# Access Compliance Report

## Public Rights-of-Way

Intersection ID: 24195	Main Street: PROVIDENCE_RD	Cross Street: BEVERLY_CREST_BV	Location: NW
ADA ID: 091D4A969308	Ramp Type: Perp	Initial Pass/Fail: Fail	Overall Compliance: No
Severity Score: 21.25			
Codes/Mitigation Info/Possible Solution		Field Measurements/Component Compliance

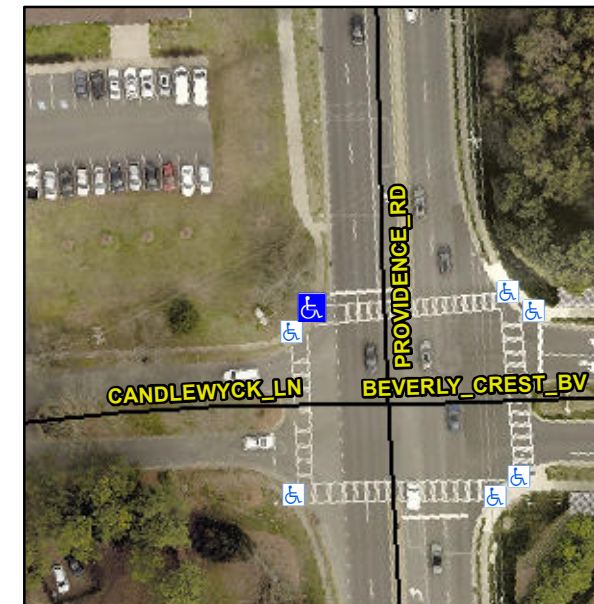
**Not Found, R304.5.1, R304.2.2**

Compliance	Description	Data	Compliance	Description	Data
N/A	Ramp Length (in)	77.0	No	Ramp Slope (%)	10.2
No	Ramp Width (in)	36.0	Yes	Ramp XSlope (%)	1.7
N/A	Flare Type LT	N/A	N/A	Flare Type RT	N/A
N/A	Flare Slope LT (%)	N/A	N/A	Flare Slope RT (%)	N/A
N/A	Flare Traversable LT?	N/A	N/A	Flare Traversable RT?	N/A
N/A	Landing Length (in)	N/A	N/A	DWS Provided?	N/A
N/A	Landing Width (in)	N/A	N/A	DWS Contrast?	N/A
N/A	Landing Slope (%)	N/A	N/A	DWS Length (in)	N/A
N/A	Landing X Slope (%)	N/A	N/A	DWS Full Width?	N/A
N/A	Landing Curb? (Y/N)	N/A	N/A	DWS Offset (in)	N/A
N/A	Shared Landing?	N/A			
N/A	Gutter Ponding?	N/A	N/A	Gutter Slope (%)	N/A
N/A	Gutter Lip Ht (in)	N/A	N/A	Gutter X Slope (%)	N/A
N/A	Painted X Walk1?	No	N/A	Painted X Walk2?	N/A
	X Walk 1 Direction	To E		X Walk 2 Direction	N/A
N/A	X Walk 1 Width (in)	N/A	N/A	X Walk 2 Width (in)	N/A
	X Walk 1 Slope (%)	4.4		X Walk 2 Slope (%)	N/A
	X Walk 1 X Slope (%)	2.3		X Walk 2 X Slope (%)	N/A

**Remove & Replace Entire Ramp.**
